CPP Project 8504

Project: The Darling Exchange North Plot and Square

Please find herein a response to submissions and assessment of the proposed amended development in relation to the State Significant Development (SSD) Development Application (DA) for the development of the North Plot and Square in Darling Square (SSD 7021), to respond to the key issues raised by the Department of Planning and City of Sydney:

Figure 1: Pedestrian wind speed measurement locations with comfort/distress ratings
Ground Level

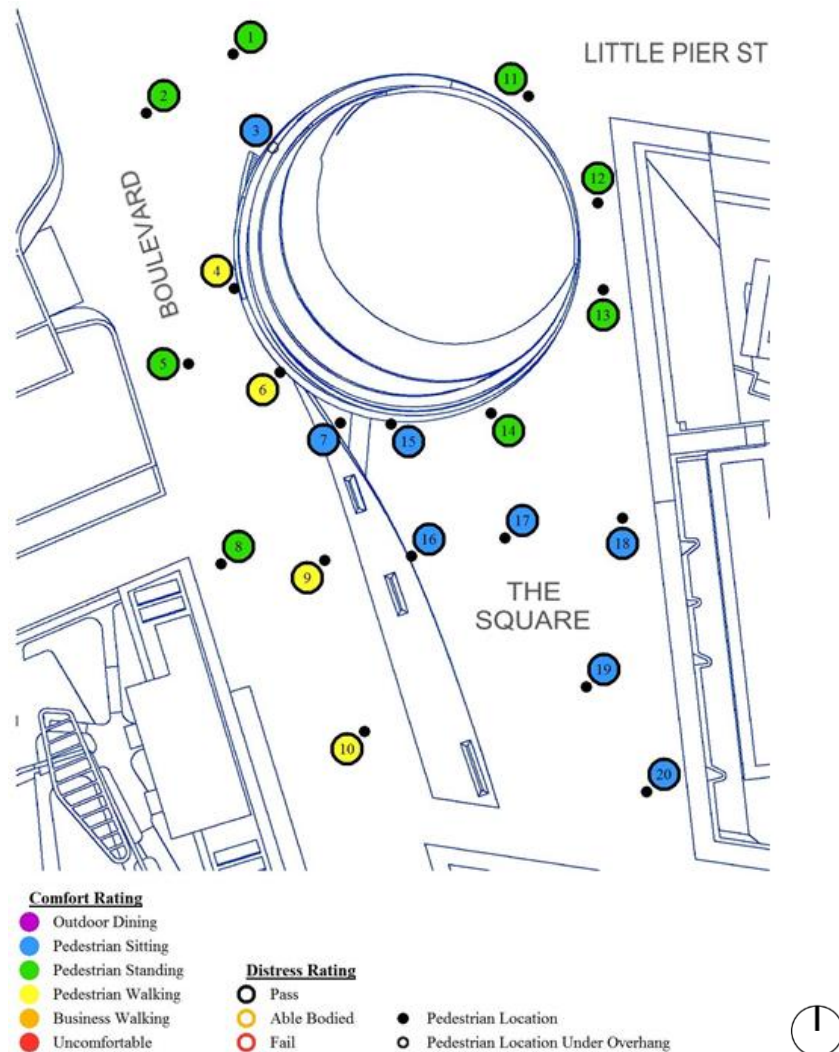
"Suggest additional mitigation to improve the wind environment around the North Plot"

Wind tunnel test results reported in 'CPP8504_The Darling Exchange_REP_PW_R02' show the wind environment around the development was found to be suitable for pedestrian standing and sitting activities at most locations, under the Lawson comfort criteria; with all locations passing the Lawson distress criteria, Figure 1.

Figure 2: Proposed mitigation measures – North-west entrance

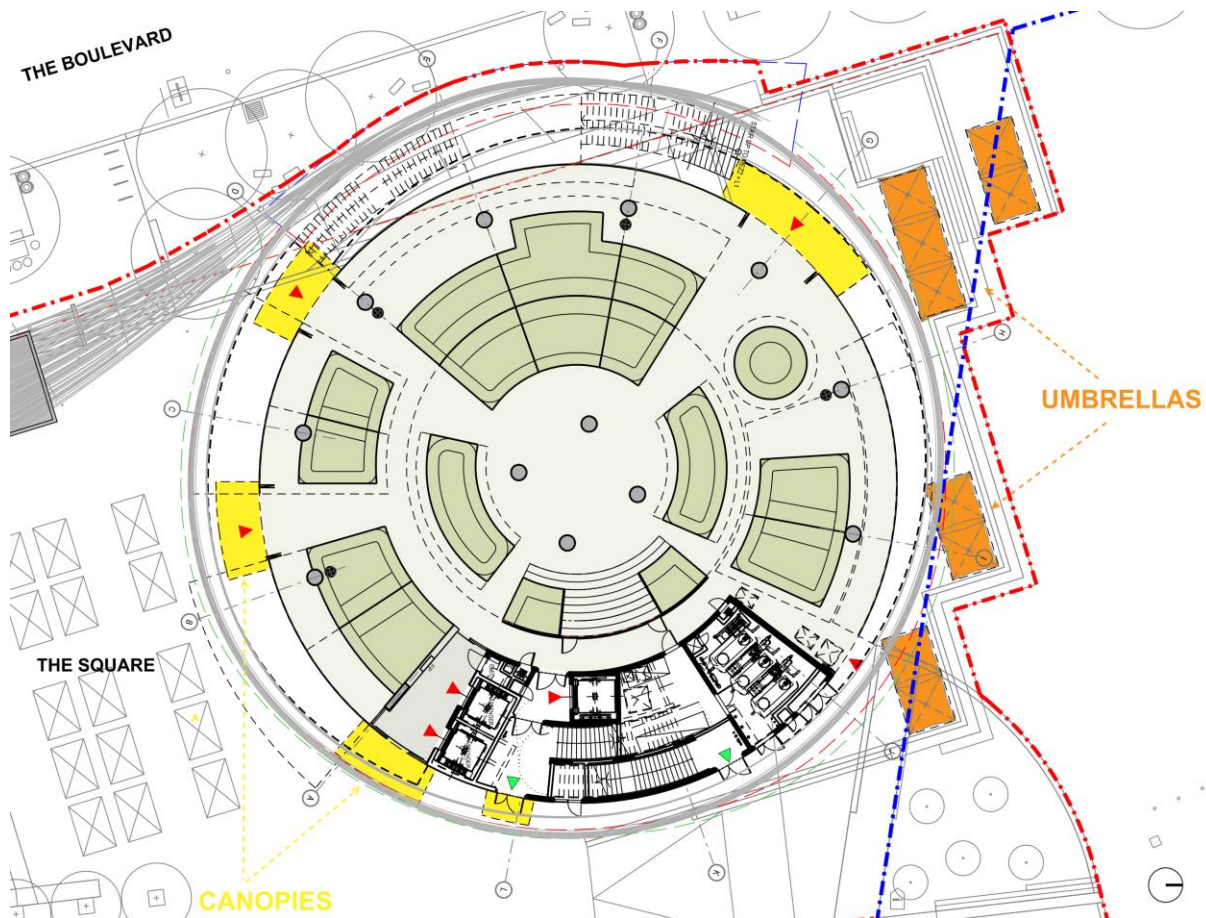
Significant wind effects are predicted at the outdoor space in the North Plot building. In the case of the North Plot, the wind assessment recommends enclosing the affected outdoor space."

- the addition of an awning at the north-west entrance;
- the addition of fixed umbrellas on the northern terraces;
- the addition of an awning at the lobby entry of the building;
- the addition of an awning at the south-east entrance; and
- Exaggeration of the shifting plates.

The additional awning to the north-west entry, exaggeration of the shifting plates and the addition of umbrellas on the northern steps, are expected to provide improved wind conditions in this area around the North Plot. Enclosing this area is not required.

To the south, the addition of awnings at the key lobby and south-east entries will provide shielding from downwash wind conditions, Figure 2. The awnings are expected to provide improved wind conditions in this area around the North Plot.
